## **Volare Carburetors, LLC**

## ***Service Bulletin (SB-4)***

### **Subject: BOWL CLEARANCE – MA- SERIES CARBURETORS**

**Applicability:** *This Service Bulletin (SB-4) applies to MA-2, MA-3, MA-4, MA-4-5, MA-4-5AA, MA-5, MA-5AA, MA-6 and MA-6AA model float carburetors manufactured by Volare Carburetors LLC (“Volare”), and its predecessors Precision Airmotive Corporation, Facet Aerospace Products Company, and Marvel-Schebler (Borg-Warner) (hereinafter “Volare”) that are equipped with a brass float assembly.*

**Fig. 1**

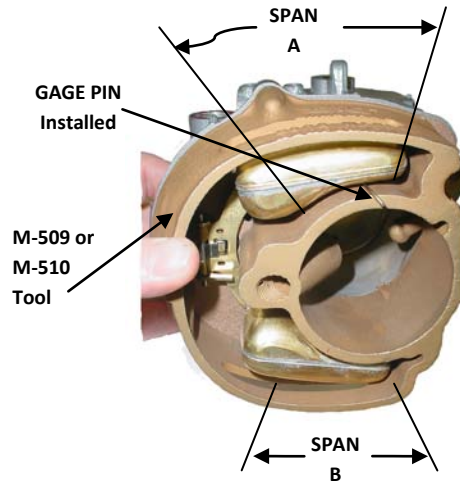
1. **Reasons:** **Warning:** **Failure to follow this advice may result in engine malfunction, damage, injury or death.** Reports of sticking, leaking and/or worn floats have been received, see Figure 1. The specified float/bowl clearance **MUST** exist to ensure proper operation.

**Floats with Rubbing Wear – FEB 2009**

**Fig. 2**

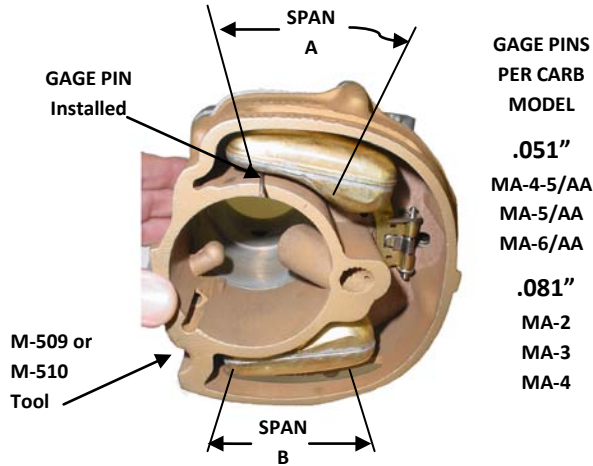
With the clearance tool M-510 used with the (MA-3, MA-4 series) or M-509 used with the (MA-5, MA-6, MA-4-5 Series) in place, orient the carburetor body with one pontoon uppermost, see Figure 2. Check the clearance between the float pontoon and the bowl wall. A .081 inch gage pin (models MA-2, MA-3 & MA-4), or a .051 gage pin (models MA-4-5, MA-4-5AA, MA-5, MA-5AA, MA-6 and MA-6AA) must pass between the lower surface of the upper pontoon and the throttle bore wall and between the lower surface of the lower pontoon and the lower bowl wall without touching either pontoon. Reorient the carburetor so that the other pontoon is uppermost, see Figure 3. Repeat the clearance check. If, as the gage pin is moved along between the float and the bowl wall the gage pin contacts either pontoon, float clearance is inadequate and the float assembly must be replaced.

**Fig. 6**

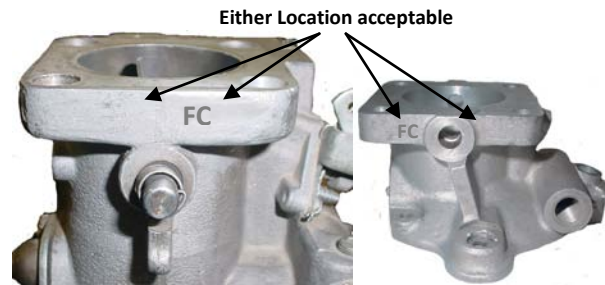
5. **Identification/Marking:** Upon completion of this Flight Safety Service Bulletin, stamp the letters "FC" ( $\frac{1}{8}$  inch tall (nominal) characters) on the flange adjacent to the throttle shaft, see Figure 6.
